SUBJECT: REVIEW OF PROPOSED EVAPORATION PONDS - OGLE PETROLEUM, INC., BISON BASIN PROJECT - AMENDMENT NO. 1 TO LICENSE NO. SUA-1396

SUBJECT: REVIEW OF PROPOSED EVAPORATION PONDS, OGLE PETROLEUM,
INC., BISON BASIN PROJECT; AMENDMENT NO. 1 TO LICENSE
NO. SUA-1396

SITE PLAN
HOWARD & DONLEY ASSOCIATES, INC.
CONSULTING ENGINEERS & GEOLOGISTS

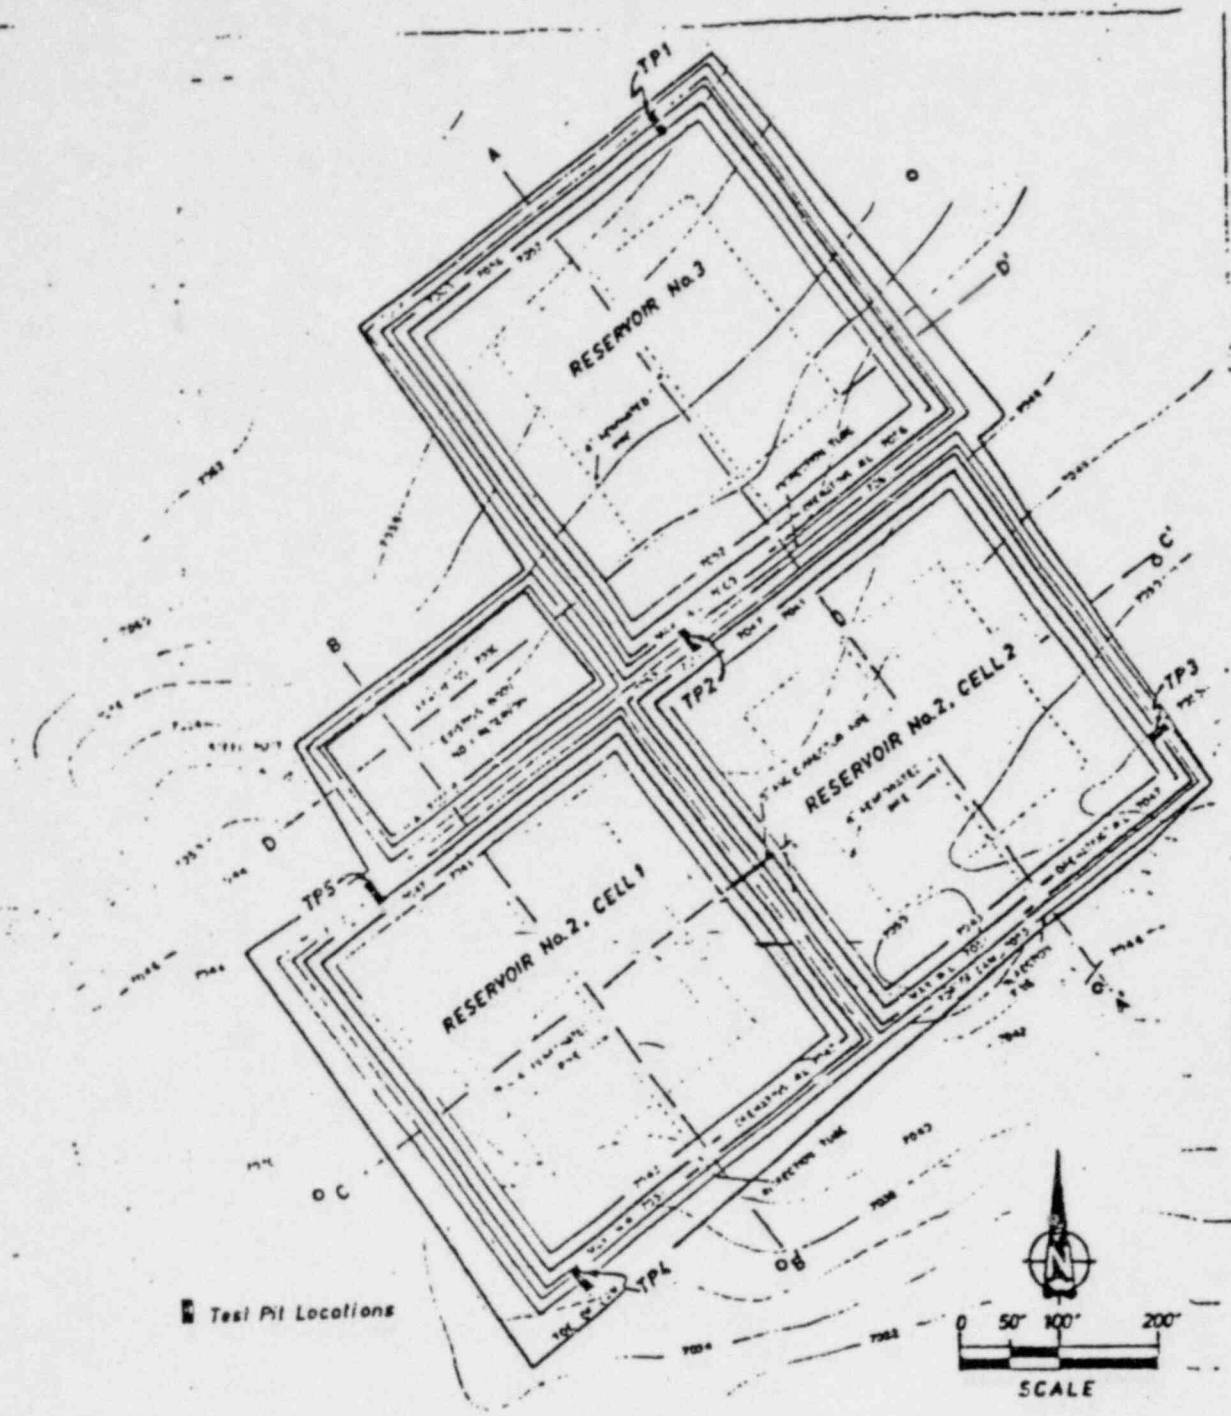
Once excavation and embankment construction are complete, the leak detection piping network would be put into place and a 30 mil reinforced Hypalon liner would be installed. The leak detection system would consist of 4 inch diameter perforated PVC pipes placed in a bedding layer of sand and arranged as shown on the attached figure. Each of the three ponds would have an independent leak detection system.

c. The leak detection system for each pond shall consist of a 4-inch diameter PVC piping network placed in a bedding layer of sand and/or gravel directly beneath the pond liner. An inspection tube connected to the system shall extend up the southeast slope of each pond. Prior to liner placement, the leak detection system shall be tested by the introduction of liquid samples into the sand layer to assure that it functions properly. Resulting flow paths, flow volumes, travel times and system performance shall be determined.
